Staff Report

Re: **Pier 70 Crane Cove Park Master Plan (“Park Master Plan”)**

1. Project Review

This is the third review by the Waterfront Design Advisory Committee (WDAC) of the Pier 70 Crane Cove Park Project. The project is the Pier 70, Crane Cove Park Master Plan, Phasing Plan, and proposal for a first phase of park improvements.

exhibit 6: September 2013 Crane Cove Park Master Plan Revisions

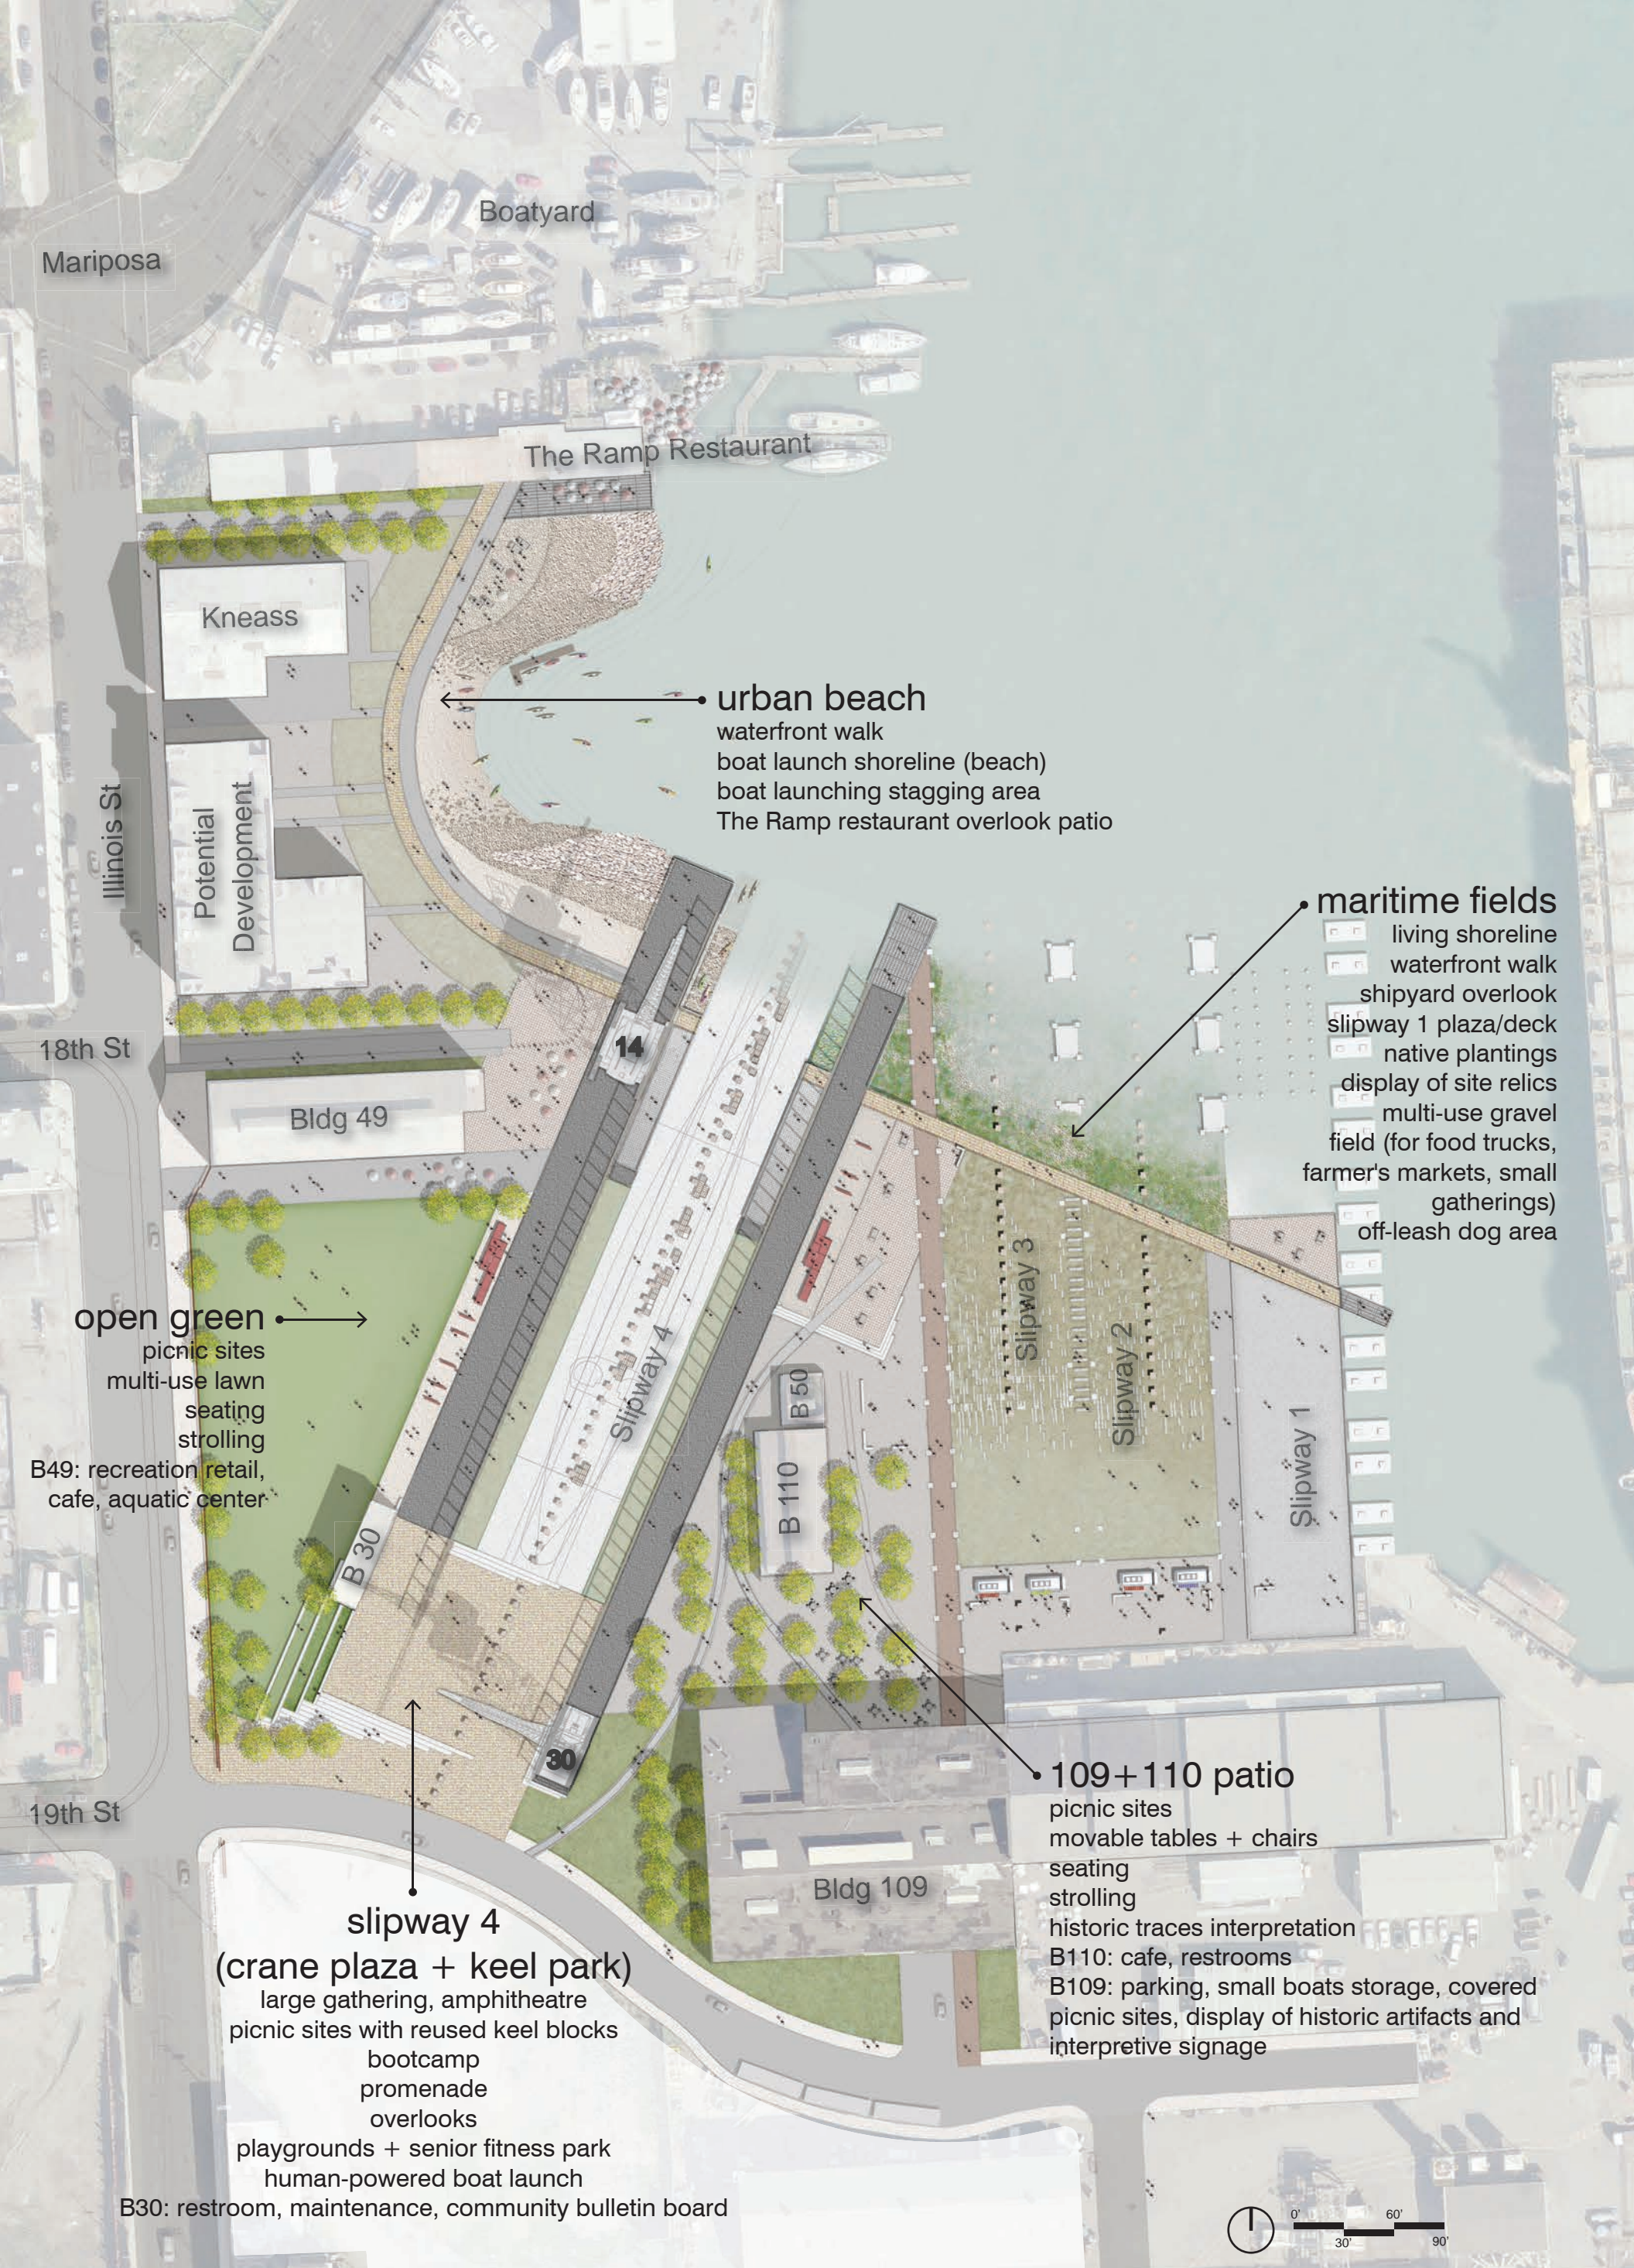
- A. Slipway #4 very important, it is a 3D object, a lot of the site should be oriented around it.
Elements of the overall design were simplified and the children's play areas were reconfigured to align with Slipway #4 to reinforce the features dominance.
- B. Maritime use should be a driving force of this design.
The design removed the wharf structure along the shoreline of slipways 1-3 that created an obstacle and cut the connection between the slipways and the cove. Three new "overlooks" project into the cove to allow an over water experience and closer views of the ship repair operations.

- C. Land water connection should be used as a design clue for orienting site elements.
The primary orientation of site elements and plantings is a north south access, following the historic traces and processes of ship building and lurching into the Bay. In addition the above referenced wharf was removed from the concept.

- D. Areas around slipway 4 should be simple – so park is largely about slipway 4 and shipbuilding beyond the site.
Elements of the overall design were simplified and the children’s play areas were reconfigured to align with slipway for and reinforce the features dominance.

- H. Upper park is too curvilinear, gardenesque.
The design of the beach area follows the existing and historic shoreline and is designed to accommodate human powered boats, the pathway traces the shoreline form of this part of the cove during the WWII era, which is the corresponding configuration with the rest of the historic elements being preserved. Adjacent planting has been minimized and planted consistently throughout the park, eliminating any “gardinesque” gestures.

September 2013 CCP Master Plan Revisions:

1. Removed wharf at end of slipways 2 and 3
2. Added new overlook at end of runway
3. Completed path along entire shoreline
4. Created new destination overlook at end of shoreline path, facing shipyard
5. Redesigned linear playgrounds and play area bands to reinforce slipway 4 layout
6. Removed northern development site from project
7. Relocated building 30 closer to entry
